Re: Larry H Miller Coors Bypass
9820 Coors Blvd NW
Traffic Circulation Layout
(B14D017)

DRAINAGE AND TRANSPORTATION INFORMATION SHEET (REV 09/2015)

RE: Coors / Coors Bypass Improvements

**TRAFFIC CIRCULATION LAYOUT
TRACT B,
LANDS OF BLACK DEVELOPMENT ONE
9820 COORS BLVD NW**

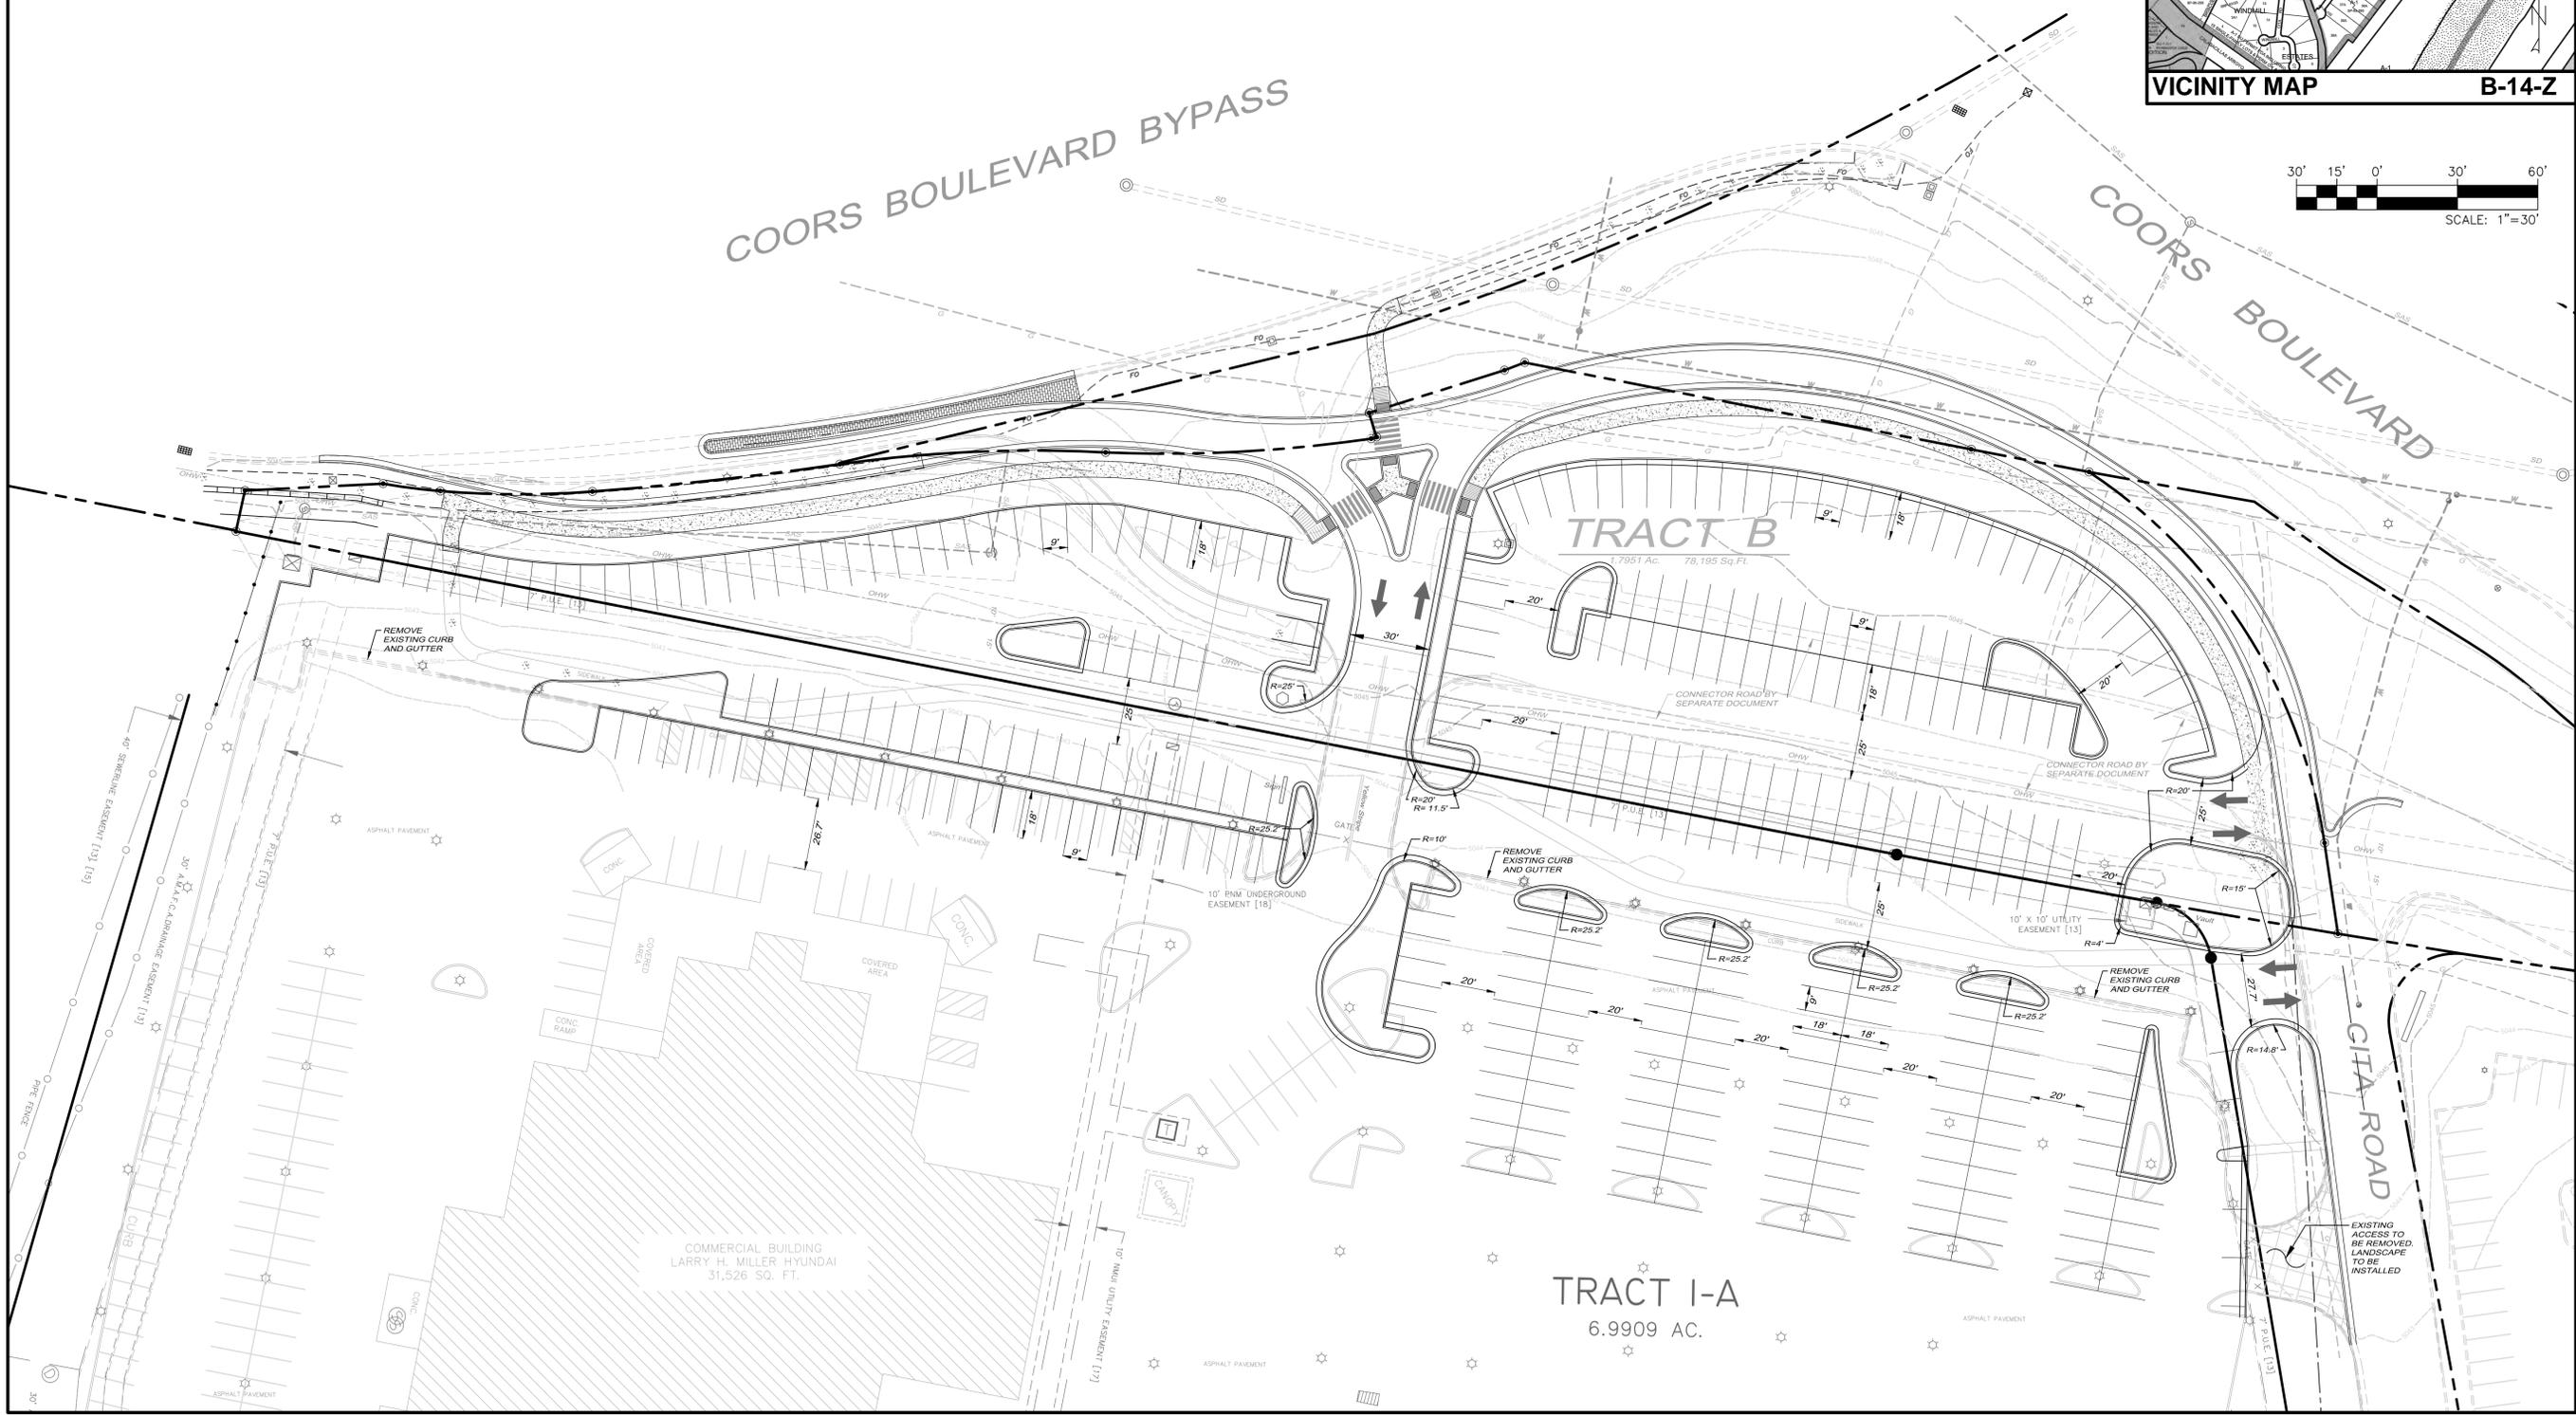
1. List the number of parking spaces required by the zoning code as well as the proposed number of parking spaces. Will the proposed parking be for patron use or car display?

2. The traffic circulation layout must be stamped, signed, and dated by an engineer or architect licensed in the state of New Mexico.
3. Identify the right of way width, medians, curb cuts, and street widths on Coors Blvd and Cita Rd.

4. Clarify existing property lines and proposed property lines
5. Please list the width and length for all existing and proposed parking spaces.
6. Parking spaces cannot cross over the lot lines.

7. The handicap accessible spaces must be a minimum of 8.5 ft. in width.
8. The handicap accessible spaces must include an 8 ft. wide van access aisle; all other aisles should be 5 ft. in width.

9. The ADA accessible parking sign must have the required language per 66-7-352.4C NMSA 1978 **"Violators Are Subject to a Fine and/or Towing."** Please call out detail and location of HC signs.

10. The ADA access aisles shall have the words **"NO PARKING"** in capital letters, each of which shall be at least one foot high and at least two inches wide, placed at the rear of the parking space so as to be close to where an adjacent vehicle's rear tire would be placed. (66-1-4.1.B NMSA 1978)

11. Per DPM, a 6 ft. wide ADA accessible pedestrian pathway is required from the public sidewalk to the building entrances. Please clearly show this pathway and provide details.

12. Per DPM, a 6 ft. wide ADA accessible pedestrian pathway is required from the HC parking stall access aisles to the building entrances. Please clearly show this pathway and provide details.

13. It is not apparent what type of pavement surface is being proposed. A hard driving surface will be required as part of this proposed project for parking area and drive aisles.

14. Please provide a sight distance exhibit (see the *Development Process Manual, Chapter 23, Section 3, Part D.5 Intersection Sight Distance*).
15. Please add the following note to the clear sight triangle: "Landscaping and signage will not interfere with clear sight requirements. Therefore, signs, walls, trees, and shrubbery between 3 and 8 feet tall (as measured from the gutter pan) will not be acceptable in this area."

16. Please specify the City Standard Drawing Number when applicable.
17. Work within the public right of way requires a work order with DRC approved plans. Clarify area of work in the public right of way.

18. Please add a note on the plan stating "All improvements located in the Right of Way must be included on the work order."
19. DRB dedication Plat approval required prior to approval of TCL.
